**ISSUE:** Certificate of Appropriateness for alterations

**LOCATION:** Old and Historic Alexandria District  
317 Prince Street

The applicant requests a Certificate of Appropriateness to replace the existing overhead doors for fire apparatus at Fire Station 201.

# CITY OF ALEXANDRIA - FIRE STATION BAY DOOR IMPROVEMENTS - FIRE STATION 201

**C** NEW FOUR-FOLD DOOR ELEVATION  
N-1 SCALE: 1/4" = 1'-0"

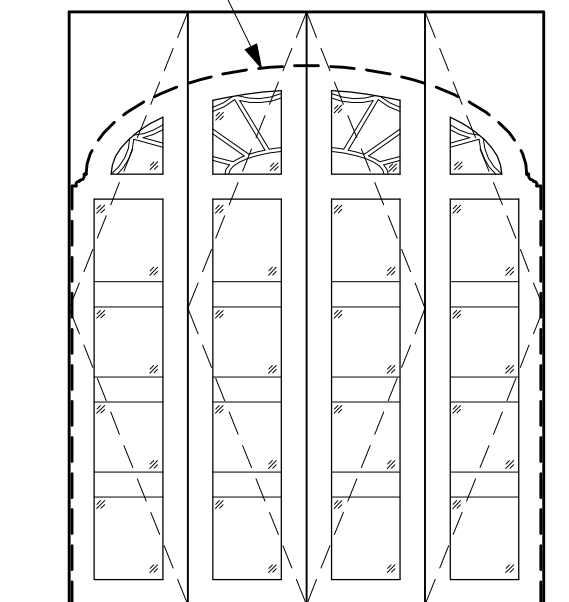
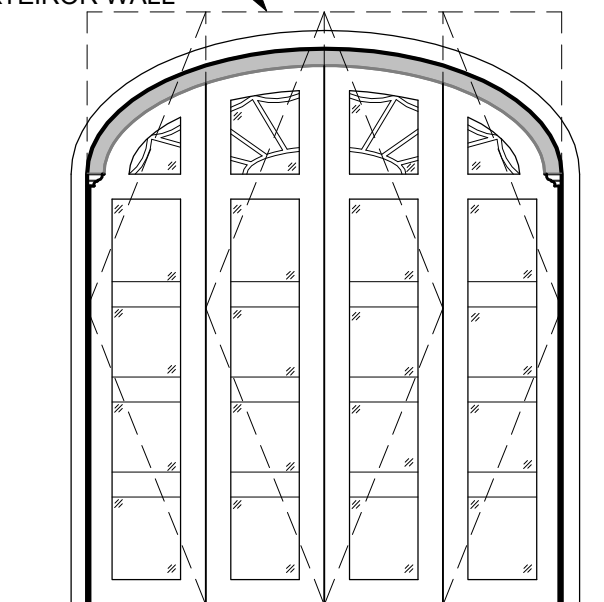
1. Eliminate the spiderweb muntins from the upper row of panels.
2. Make the visible portion of the rail at the head of the doors the same 5” width as the stiles at the perimeter and make all rectangular glass panels equal size, as shown on drawing 1/N-3.

in lieu of historic wood panels are compatible with the station but will not be mistaken for original construction. However, the muntins in the upper curved transom panes do not effectively evoke the historic fanlights, as the spiderweb muntins are interrupted by the vertical stiles at the bi-fold hinge point. Staff recommends the applicant remove them and continue the simple glass panels.

Staff notes that the doors are correctly shown on drawing 1/N-3 but are not precisely represented in the illustrative photo mock-up. Staff has therefore included a condition to clarify that the 5" width of the visible rail at the top of the doors must match the width of the stile at the perimeter of the opening and that all of the rectangular glass panels be equal in size.
